## Appendix 2 – Response to ‘Fact checking’ exercise

Table A – Fact-checking exercise for Consultation Draft (Regulation 18)

Figure 4: Walking Isochrone from Albourne Primary School to Site (courtesy of TravelTime Mapping)

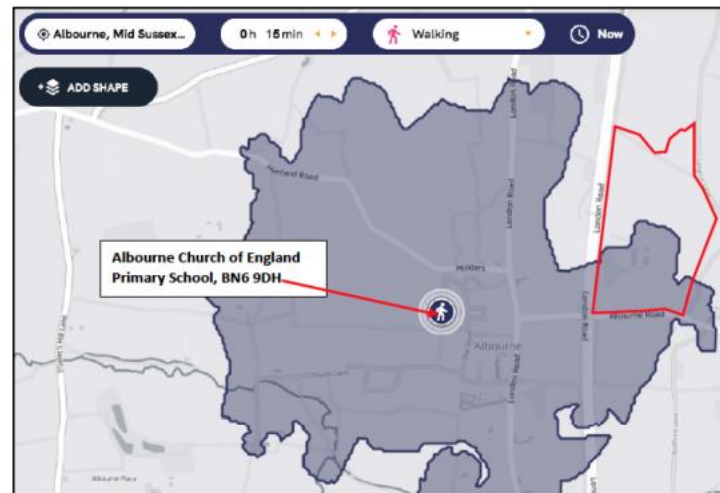
12 – primary school -the draft proforma (for fact checking) sets out that the site is within a 20-minute walk of a Primary School. However, our own review of Time Travel Mapping however shows that a large proportion of the site could walk to Albourne Church of England Primary School with a 15-minute walk – as demonstrated in Figure 4 below.

Figure 5: Walking time to Albourne Primary School (courtesy of Google Maps)

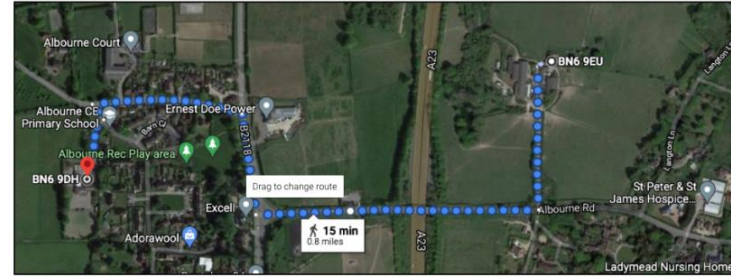
Again, we have cross referenced this with evidence held within google maps and using the main farm buildings in the middle of the site as the measurement point. This confirms that the lion's share of the site is indeed located within a 15-minute walk of Albourne Primary as demonstrated in Figure 5 below.

Figure 6: Walking Isochrone from Hurtpierpoint Primary School to Site (courtesy of TravelTime Mapping)

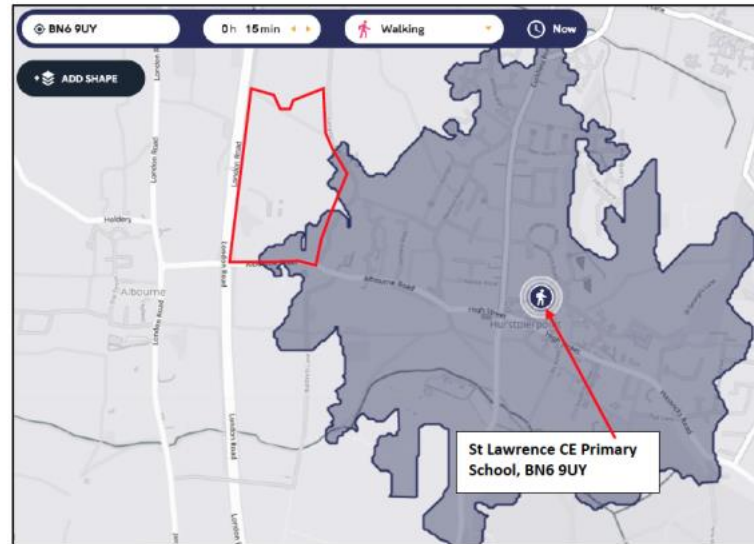
It should also be noted that the site is also located within walking distance of another school, St Lawrence CE Primary School in Hurstpierpoint. This is slightly further away but still eastern parts of the site are also within a 15-minute walking distance as demonstrated in Figure 6 below.

Combined, the lion's share of the site is within a 15-minute walk of a primary school and as such we ask for the assessment to be revised from 'Neutral' to 'Positive'
